Modification Recommended Service Note

P9371B Keysight Streamline Vector Network Analyzer

Serial Numbers: From MY61100288 to MY61100353

Potential lifted front panel overlay

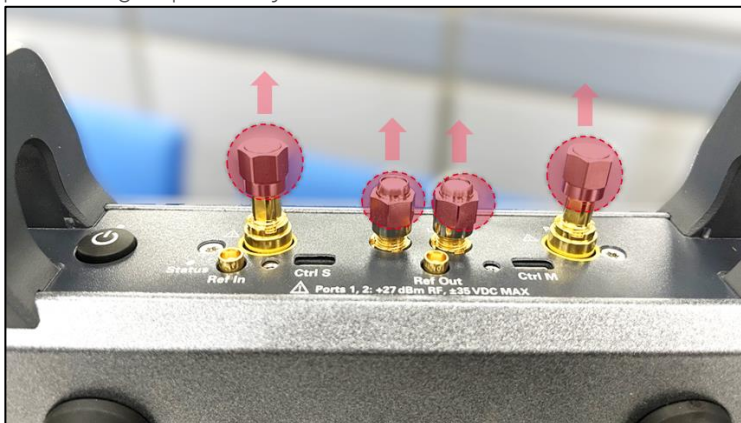
Keysight streamline series vector network analyzer (VNA) of serial number range identified in service note cover page might potentially exhibit the following lifted front panel overlay symptom.

Apart from cosmetic imperfections, the lifted front overlay could have led to non-fully attached *Ctrl S* micro-HDMI cable connector in multi-VNAs setup configuration.

-> Apply this service note only if end users' VNA is exhibiting the following symptom.

Procedure to replace the front panel overlay.

1. Remove the front handles. Detach the 50-ohm termination (LO-In, LO-Out, Port 1 & Port 2) or protecting caps if they are attached to the VNA.

2. Pry open the existing front panel overlay and remove it from front panel.
3. Clean the metal surface thoroughly and ensure it is free of adhesive residue.
4. Affix the new self-adhesive front panel overlay onto the metal surface.
5. Reinstall (reuse) the 50-ohm terminations and port protecting caps accordingly.

6. Reinstall (reuse) the front handles.
